PRODUCT ANNOUNCEMENT

Modification to terminal plating on G7L Power Relays

Product range: G7L Power Relay

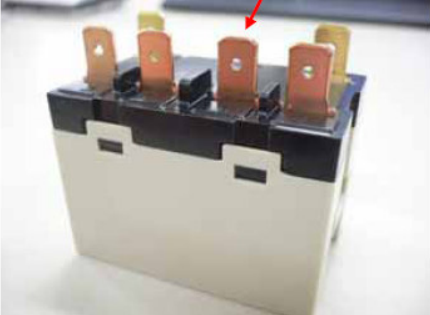
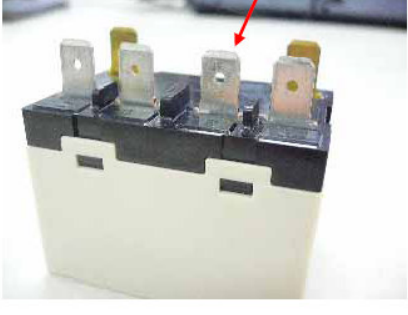
All G7L types mentioned below will have Sn-plating on the terminals as of the 1st of October 2007. The reason for this change is to improve the contact reliability.

Before	After
Surface coating of contact terminal: No-plating <div style="border: 1px solid black; padding: 5px; width: fit-content; margin: 0 auto;">No-plating</div> 	Surface coating of contact terminal: Sn-plating <div style="border: 1px solid black; padding: 5px; width: fit-content; margin: 0 auto;">Sn plating</div>
